Additional Information for Meeting, Tuesday, June 14, 2016

20. First and Only Public Hearing to Consider the Recommended Order of the Special Master on the Site and Development Plan Application for the Residential Condominiums on Blountstown Highway exhibit #19 added to Attachment #2.

RE: Residential Condominiums on Blountstown Highway
Type "A" Site and Development Plan, CPA Track
Written Preliminary Decision - Approval with Conditions
Leon County Project ID No.: LSP160001
Tax Parcel Identification Number: 21-31-20-007-0030

DATE: 11/15/2021
 TIME: 10:00 AM
 CONTRACT: 16XXXX
 SHEET NO: 1.0
 SHEET TITLE: COVER SHEET
 SHEET: 1.0

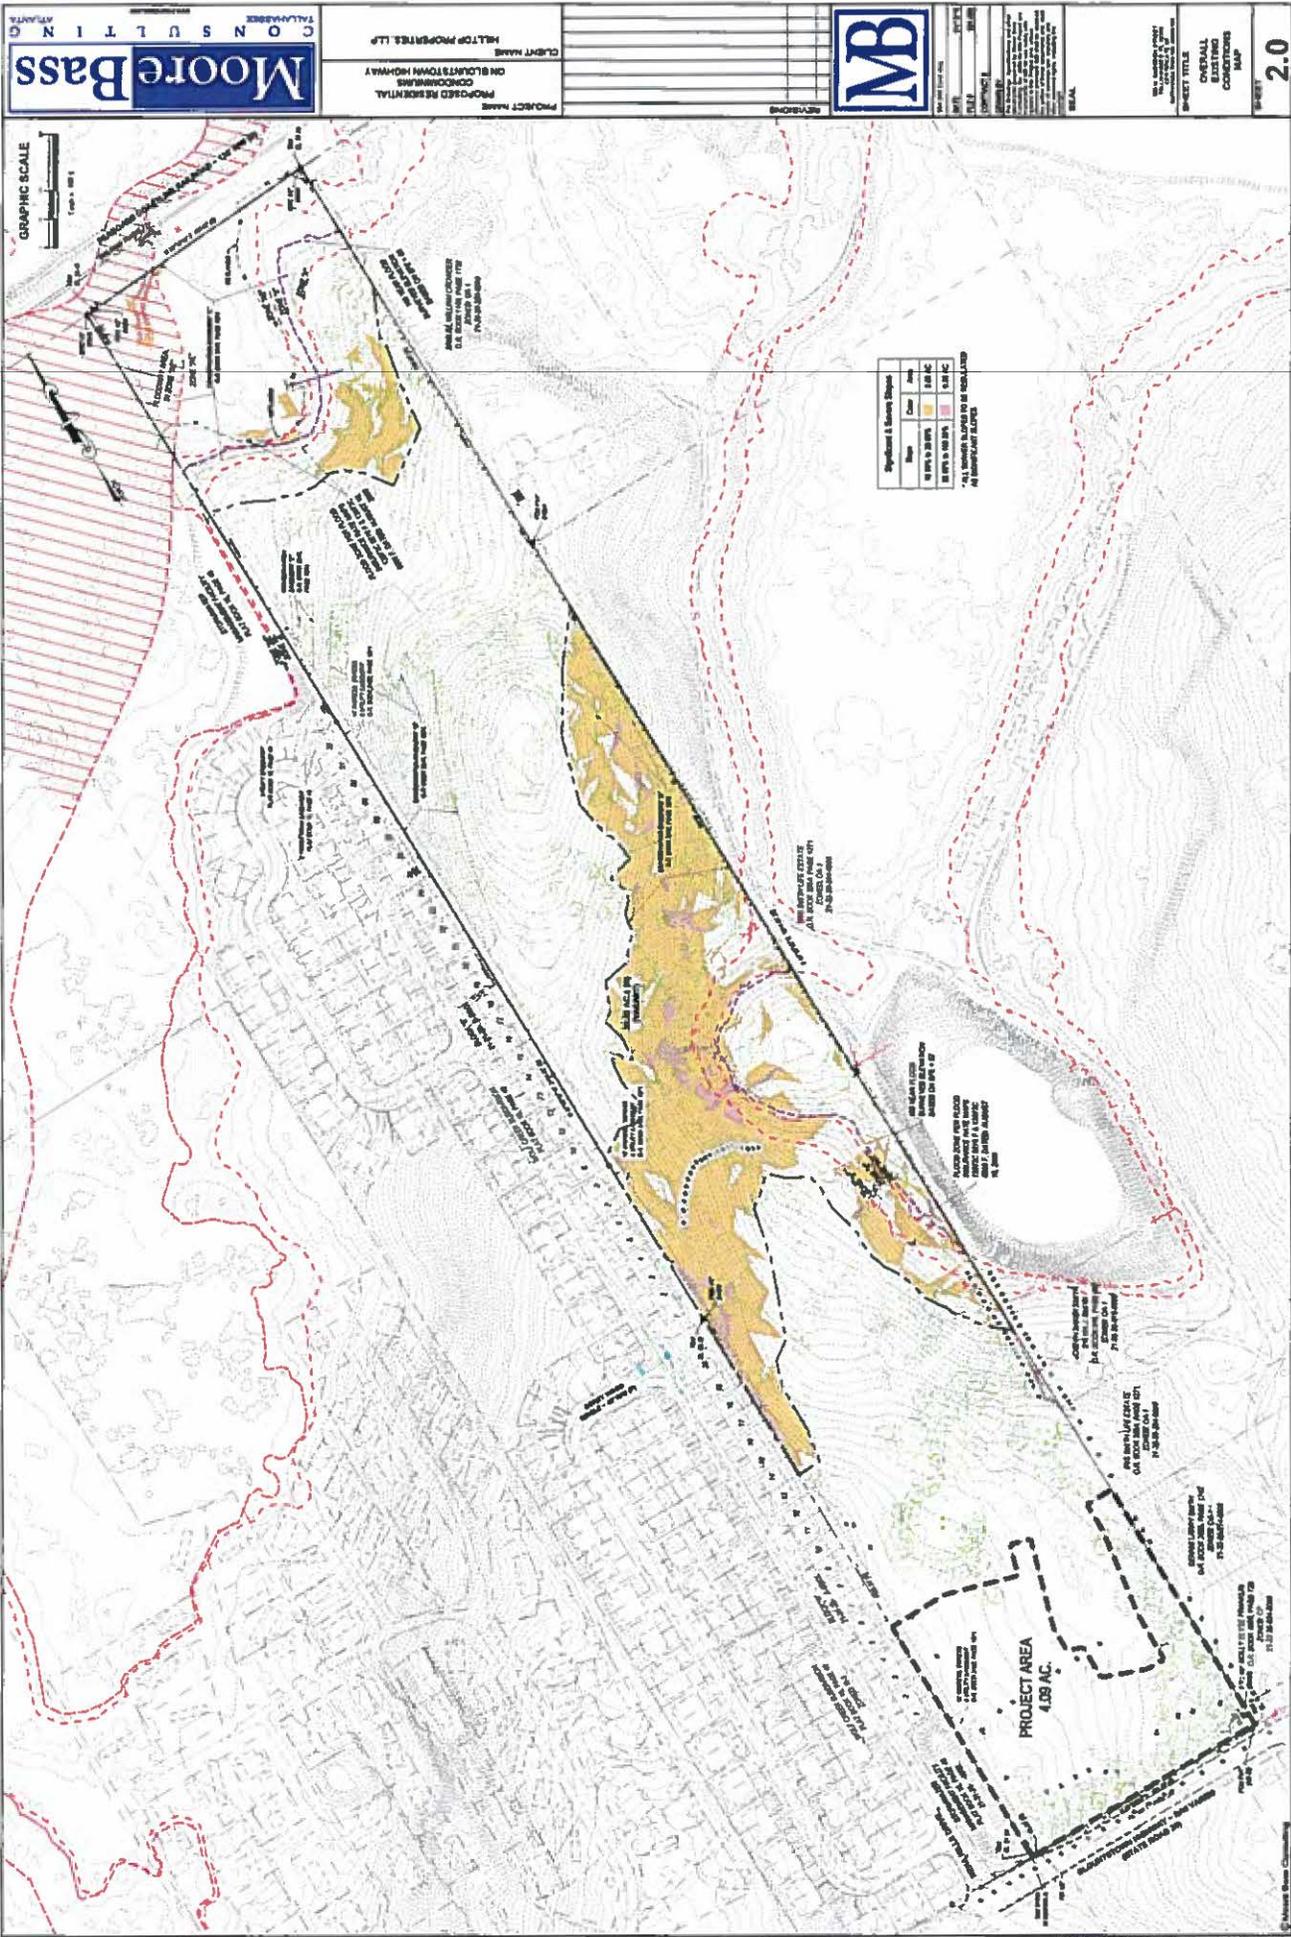
Finding #20: Please revise the cover sheet (Sheet 1.0) to reflect the project number for this project (LSP160001).

1. Sheet 1.0: Cover Sheet – Add a Conceptual Landscape Sheet to the plans and identify the sheet location in the Sheet Index. See also "Conceptual Landscape Sheet" Comments provided below.

Environmental Impact Analysis Plan with Markups

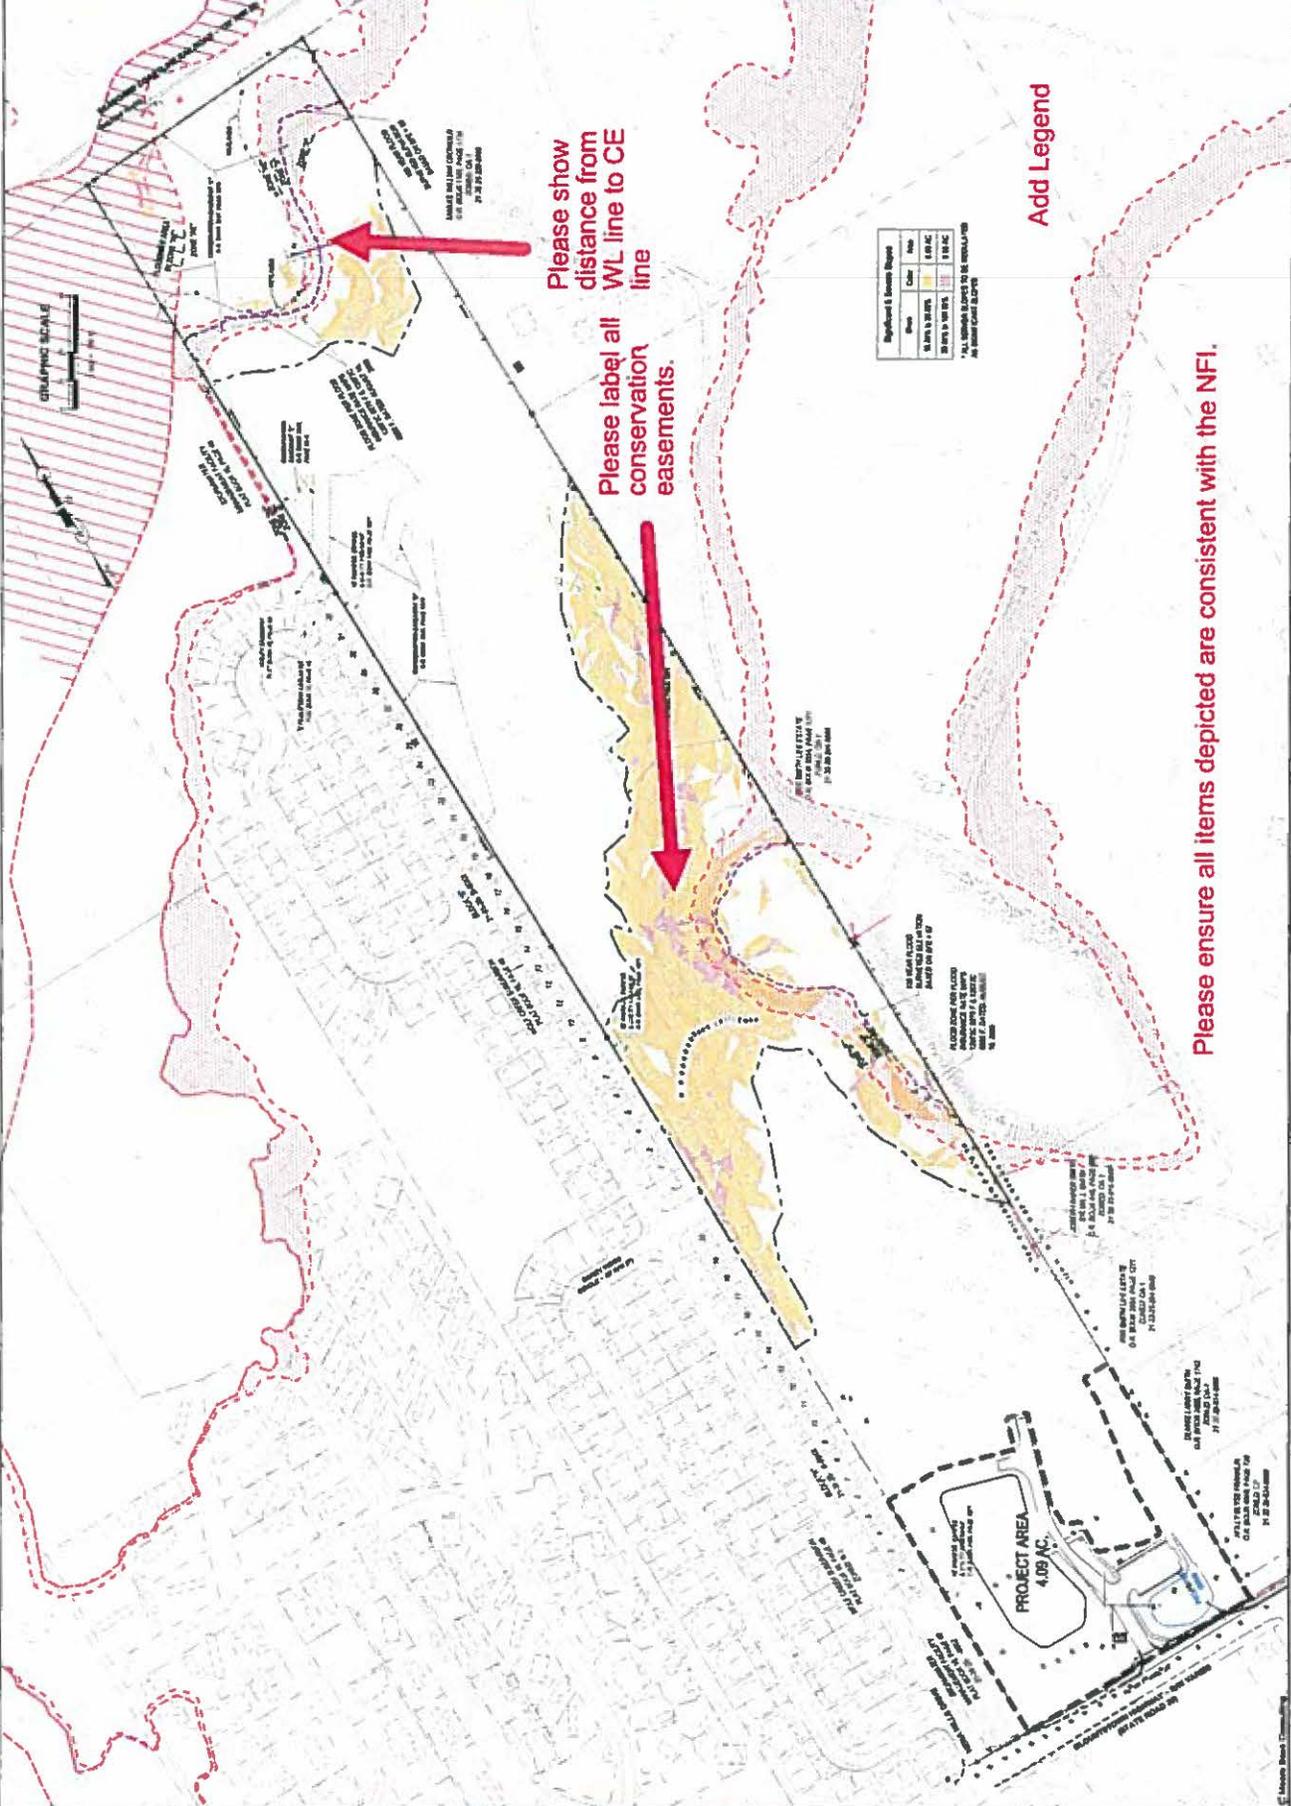
20. On sheet 2.0, please ensure that all items depicted are consistent with the approved NFI. Please label all existing conservation easements. Please add a legend (see approved NFI map).

21. On sheets 2.0 and 5.0, it appears that there is not a 50 foot buffer from the wetland to the conservation easement line. Please provide the distance from the wetland line to the conservation easement line at the narrowest point. If the distance is not 50 feet, it could be an option to increase this conservation area to the amount needed to comply with the 25 percent natural area requirement.

34. On sheet 5.0, please ensure that all items depicted are consistent with the approved NFI. Please label all existing conservation easements. Please add a legend (see approved NFI map).
35. On sheet 6.0, please ensure that potential utility conflicts have been evaluated.

PROJECT NAME PROPOSED RESIDENTIAL DEVELOPMENT ON BLOUNTSTOWN HIGHWAY		SHEET NO. 6.0
	CLIENT NAME HILTOP PROPERTIES, LLP		SHEET TITLE CONCEPT UTILITY PLAN

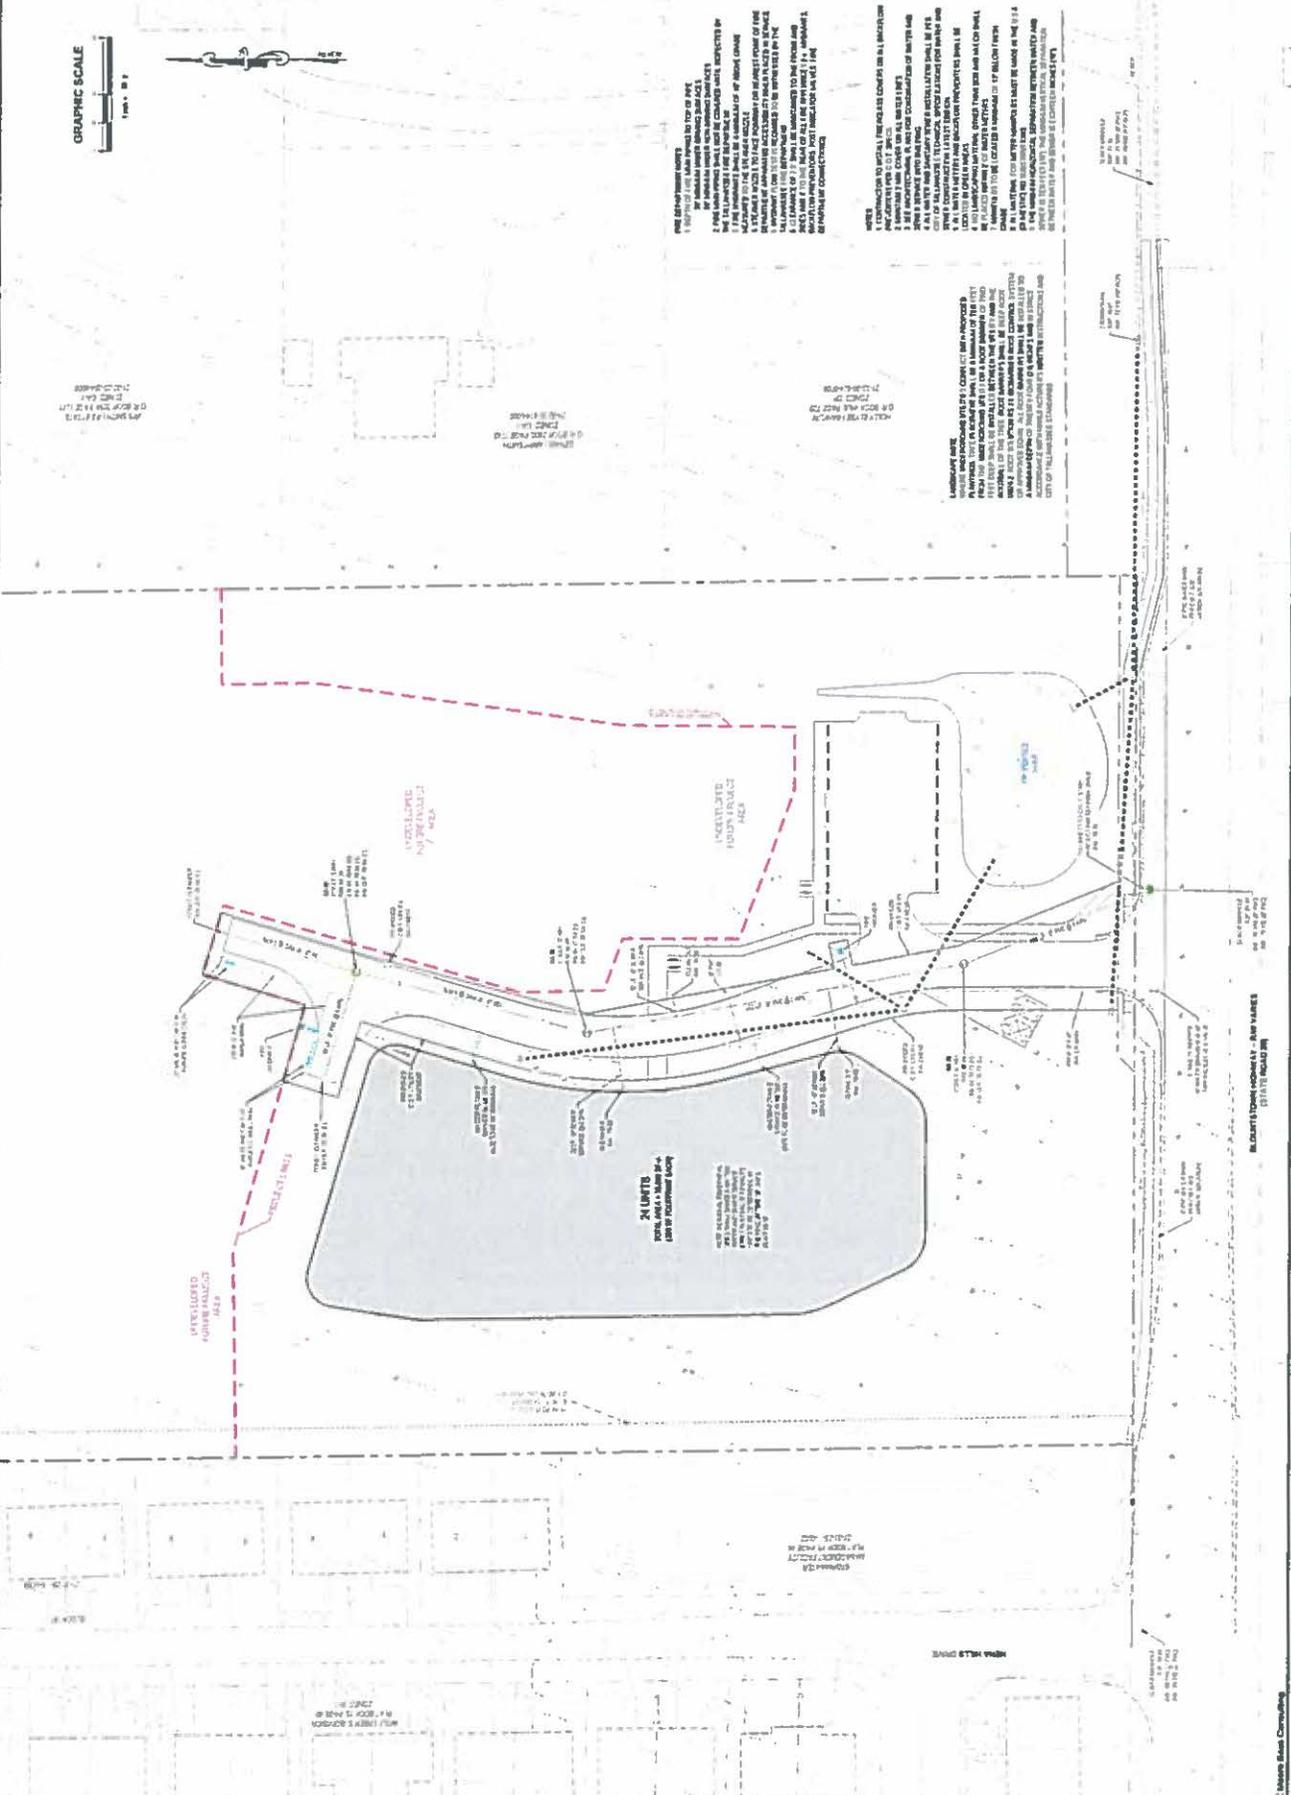
7. Sheet 6.0: Concept Utility Plan – Ensure potential utility conflicts are evaluated.
8. Conceptual Landscape Plan – The additional sheet shall address the following comments:
